APPLICATION NO.	FILING DATE	FIRST NAMED INVENTOR	ATTORNEY DOCKET NO.	CONFIRMATION NO.	
09/593,785	06/14/2000	Thomas A. Shreiner	Ap32438.70121	7746	
21003	7590 12/30/2003		EXAM	EXAMINER	
BAKER & BOTTS 30 ROCKEFELLER PLAZA			NGUYEN, CHI Q		
NEW YORK, NY 10112			ART UNIT	PAPER NUMBER	
		·	3635	3635

DETAILED ACTION

This Office action is in response to the applicant's amendment filed on 10/6/03. Since the applicant cancelled claims 6, 7, 11, 12, 17, and 18 in the previous amendment filed on 1/24/03 therefore these claims can not be reinstated even thought the generic claims have been allowed. However, the applicant could further file these claims as new claims.

Fig. 6

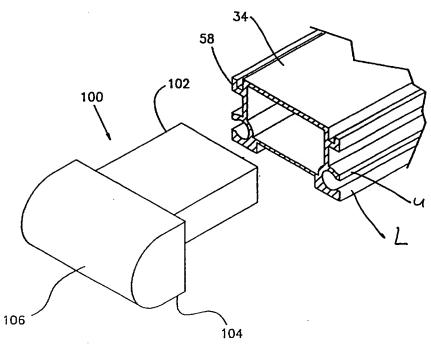
member 34 for the deck assembly (col. 13, lines 63-67, col. 14, lines 7-9). As shown in fig. 6, each of the frame members 34 having support groove, which comprising upper flange U, a lower flange L (see attached drawing fig. 6) thus capable for the formed members or planks 36 of the cover 30 slide into and engaging tongue to groove mechanism (col. 6, line 49).

Applicant's arguments filed 10/14/03 that the Hallsten reference does not include a pair of frames adapted to be secured to a building member, no elongated planar supporting surfaces on the frames, and does not span an expansion gap between building members have been fully considered but they are not persuasive because: The limitation of the building member is not positively claimed; the frame members 34 taught by Hallsten having supporting surfaces as noted by U and L and it capable to cover an

expansion join (see attached drawing fig. 6); Furthermore, the applicant's arguing limitation with respect to the manner in which a claimed apparatus is intended to be employed does not differentiate the claimed apparatus from a prior art apparatus satisfying the claimed structural limitations.
